Consensus proposal for RTS FSM for coherent PMDs (comments 140-143, 165-166)

Tom Huber, Nokia

Jeff Slavick, Broadcom

Overview of proposal

Figure 178B-y
RTS with squelch state diagram

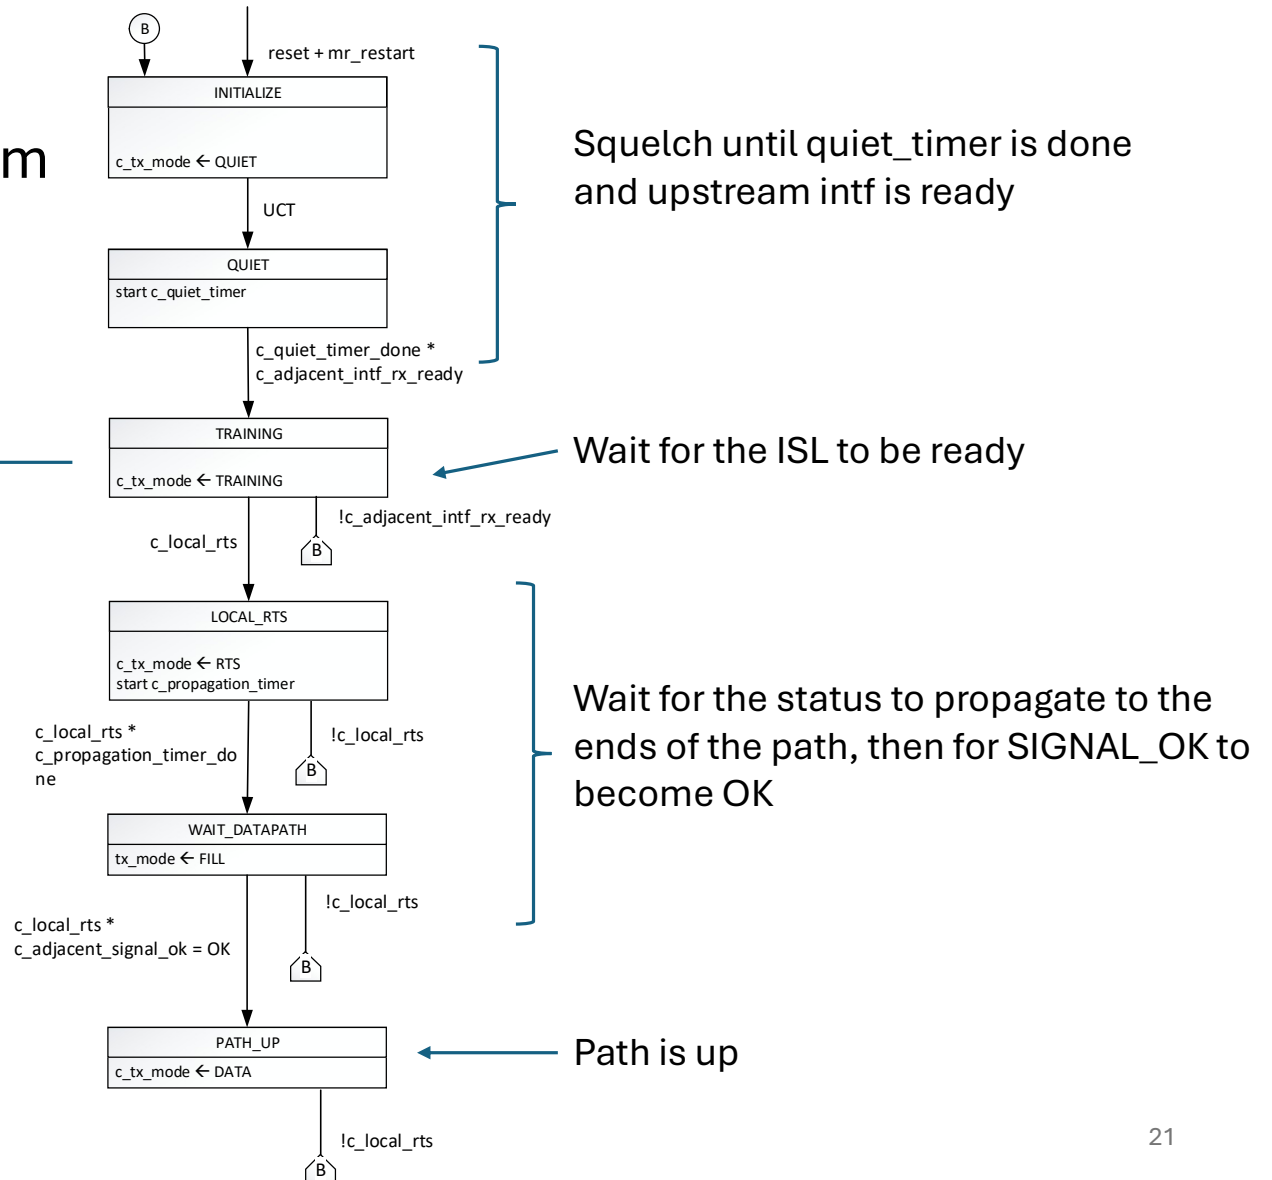
Coherent interfaces that squelch when they are not ready to send shall implement the state diagram shown in figure 178B-y.

This is used with LR1

“training” means transmitting the test pattern and tuning the rx based on the received test pattern (which may already have been done, or may happen later, since the two directions are independent)

Figure 178B-z RTS without
squench state diagram

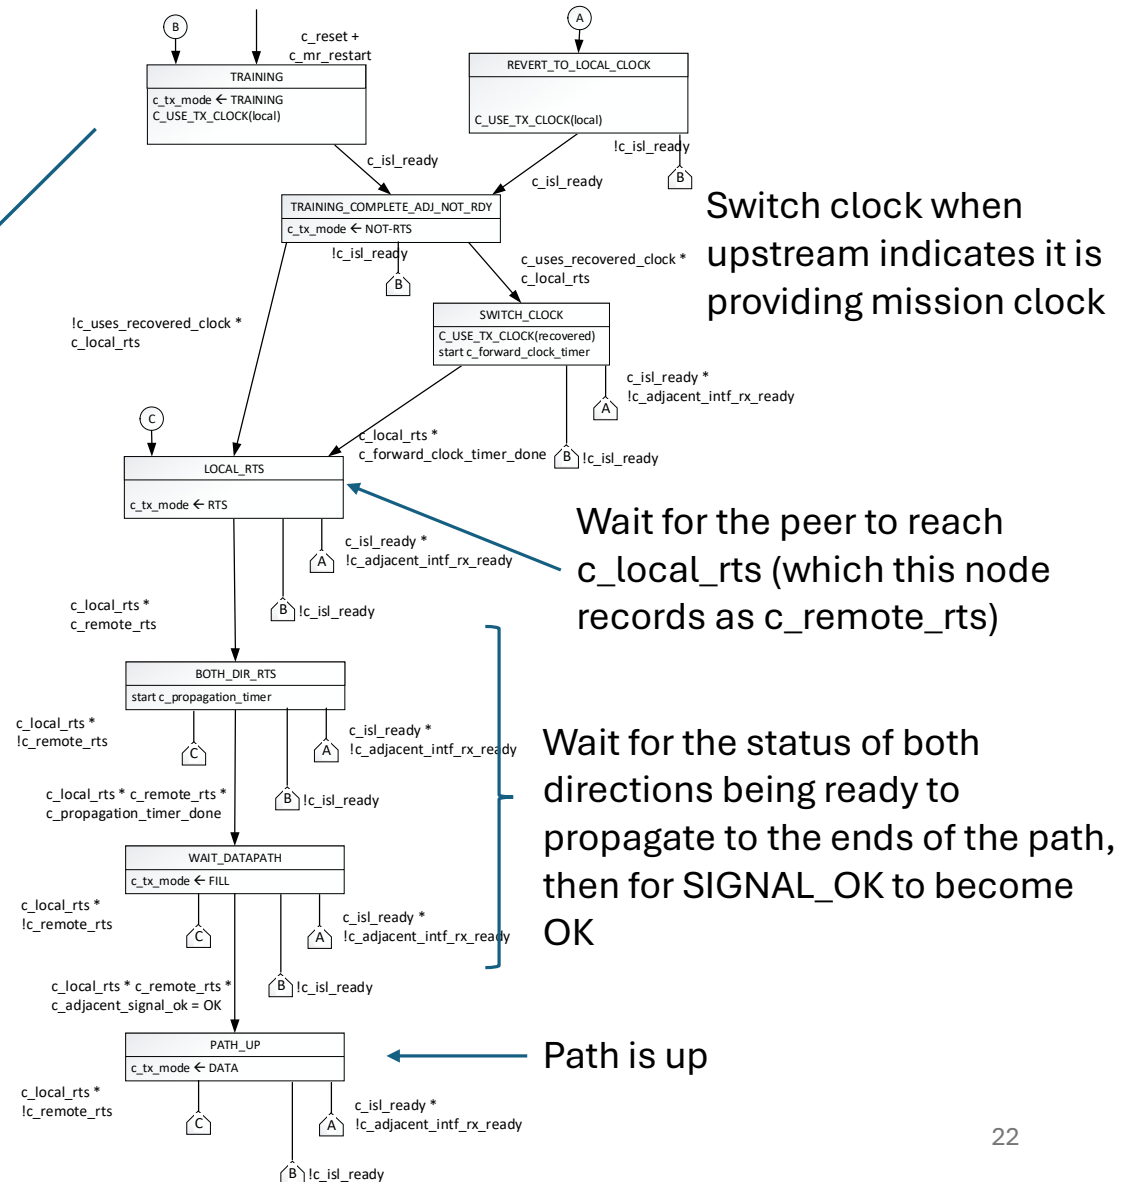
Coherent interfaces that do not squelch when they are not ready to send shall implement the state diagram shown in figure 178B-z.

Used with ER1

ER1 always transmits on its own clock, so no quiet period is needed, so the FSM starts at TRAINING. Training is complete when frame alignment is complete and the receiver is adjusted
